Planning Commission Staff Report  
Council Chambers  
December 4, 2018 1:30pm

**5. APPLICATION: AutoZone | Development Plan**

Project Number: 201810310050

Proposal: A development plan for a 7,381 square foot auto parts retail store on a 1.356-acre site

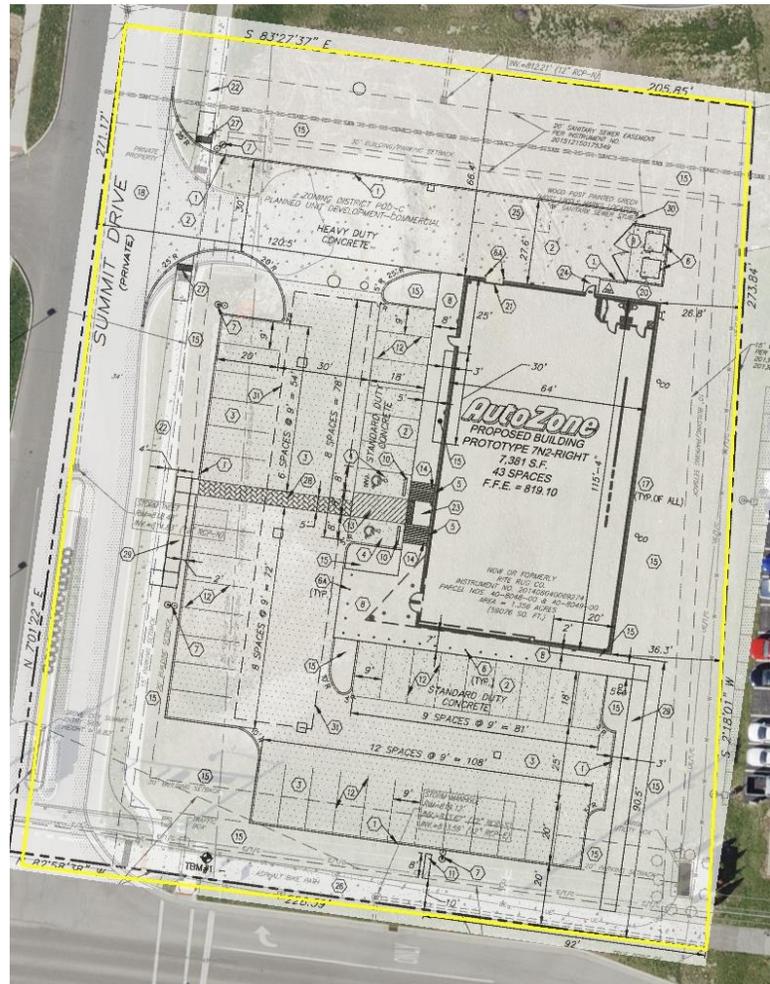
The 1.356-acre site is proposed to be accessed from a single 30-foot curb cut off of Summit Way, across from the access drive to the London Place multi-tenant retail center. The curb cut was installed at the time Summit Way was constructed and is currently 24-feet-wide to match the width of the cut across the street; however, the applicant is requesting to widen the cut to 30 feet. The north and west drive aisles through the parking lot are proposed to be 30-foot-wide and the southern drive is proposed to be 25-foot-wide. Staff is not supportive of the proposed curb cut widening or 30-foot drive aisles as drive aisles for recent commercial developments are typically approved at 24 or 26 feet wide to allow for more green space and landscaping.

Curbing on the site is proposed to be 12-inch tilt out. Sidewalks between five to eight feet in width are proposed along the west and south sides of the building. A crosswalk, utilizing a stamped brick design, is proposed through the parking lot to connect with the existing sidewalk along Summit Way.

The site to be developed currently spans two parcels – 040-008049 and 040-008048. These parcels will need to be combined to eliminate conflicts with setbacks from the internal parcel line through the site.

1. A deviation shall be granted from Section 1136.08 to permit no landscaping along the southern wall of the dumpster enclosure.
2. A deviation shall be granted to permit parking spaces sized at 162 square feet (9' by 18'), below the 180 square foot minimum.
3. The curb cut from Summit Drive shall remain its current, installed width of approximately 24 feet.
4. Drive aisles on site shall be narrowed to be either 24 or 26 feet in width.
5. The proposed EIFS shall be replaced with brick, so that the entire building is finished in brick.
6. The two parcels creating the site (040-008049 and 040-008408) shall be combined.

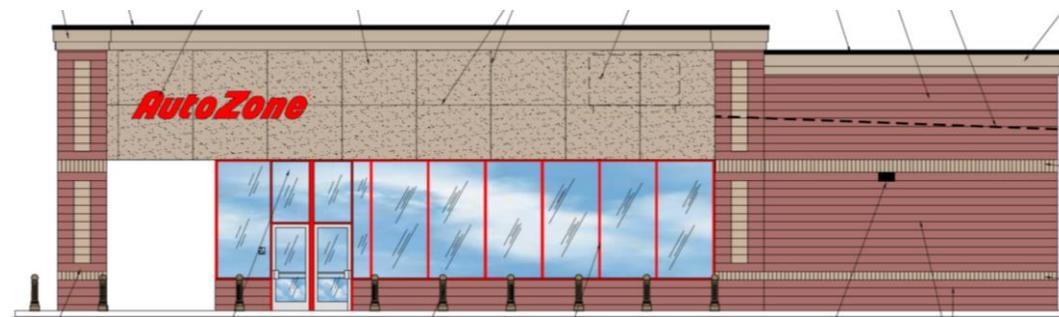
The dumpster enclosure is proposed to be landscaped on two of its sides with Arborvitae shrubs. The southern wall is not proposed to have landscaping as it is adjacent to the sidewalk adjacent to the rear service door on the structure. Staff is supportive of granting a deviation to the screening of service

structures requirement to permit no landscaping on the southern wall, as it will be screened from view by the building from London-Groveport Road and cannot be easily seen from Summit Way or from the east.

*South/Front Elevation*

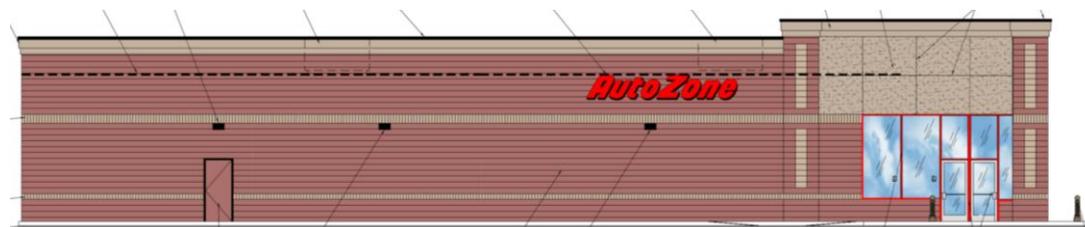
While staff is generally supportive of the building's design, the two adjacent structures, Jackson Township Fire Department Station 203 and the London Place multi-tenant retail structure, are finished entirely in brick with no EIFS. Staff believes the proposed EIFS ("Sand Dune") should be replaced with the tan brick utilized elsewhere on the structure to be more compatible with adjacent structures.

of layout and design of sites and buildings. Staff believes that the entire building should be finished in brick to be more compatible with the adjacent Jackson Township Fire Department Station and London Place multi-tenant retail development.
